Application by Equinor for an Order Granting Development Consent for the Sheringham and Dudgeon Extension Projects.

Deadline 7 – Examining Authority’s Written Questions 3

Examining Authority’s Written Questions 4

Figure 1 Recommended 'exclusion area' (blue hatched area) or reduction in RLB

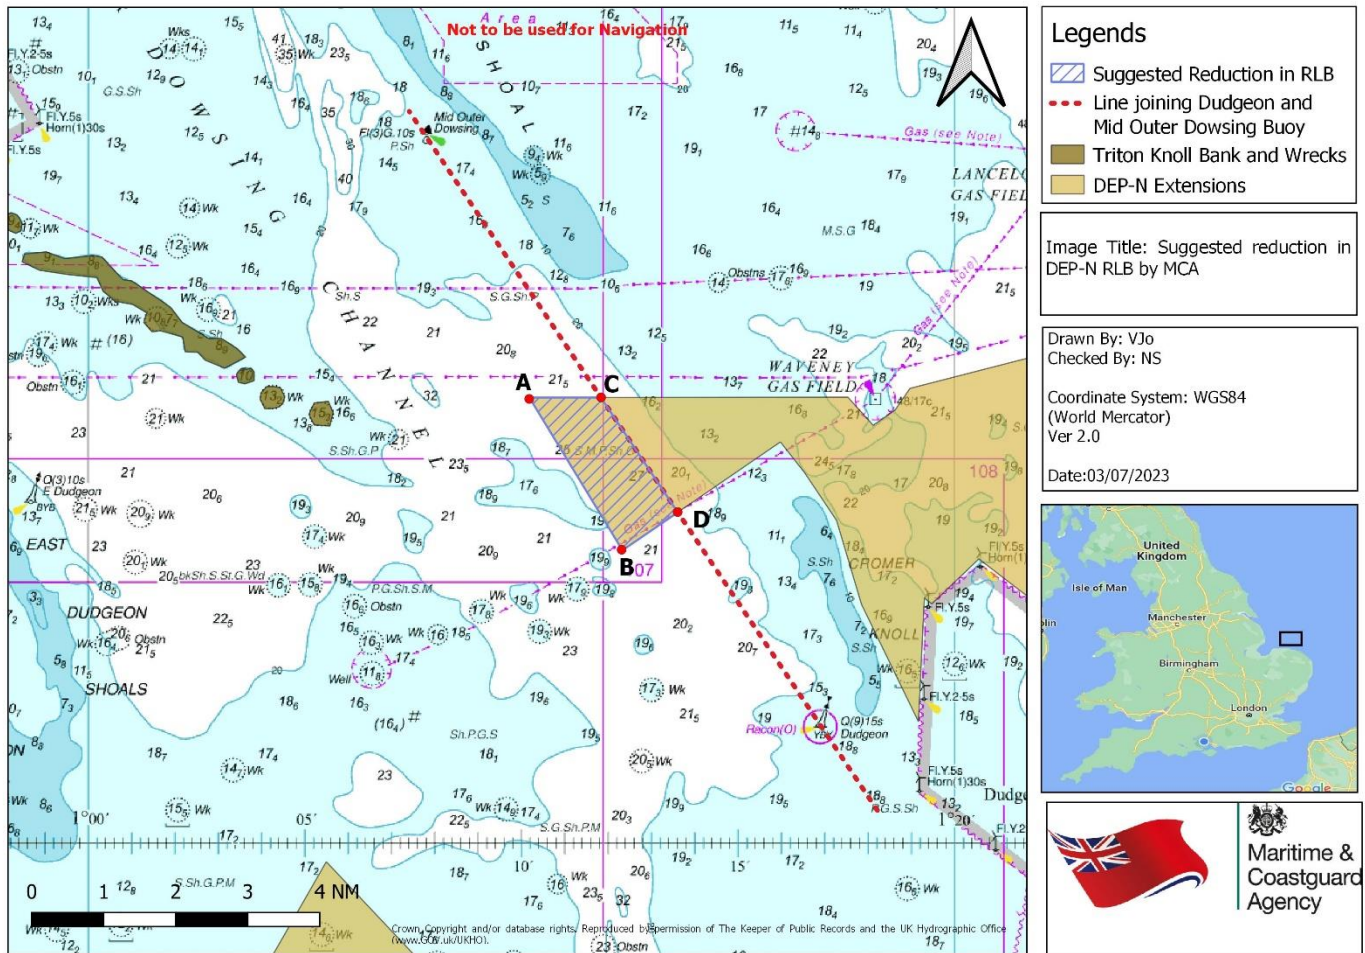
The image below (Figure 1) shows MCA's recommended 'exclusion area' or reduction to the red line boundary:

MCA would suggest that the image showing the 'exclusion area' is referenced in the DCO as a certified document and included in pre-construction plans and documentation.

MCA would suggest that latitude and longitude coordinates of the 'exclusion area' are included in the DCO, for example:

None of the infrastructure listed in Work No. *** may be installed within the area defined by the coordinates as specified below and no part of any wind turbine generator, including its blades, may overfly into the area:
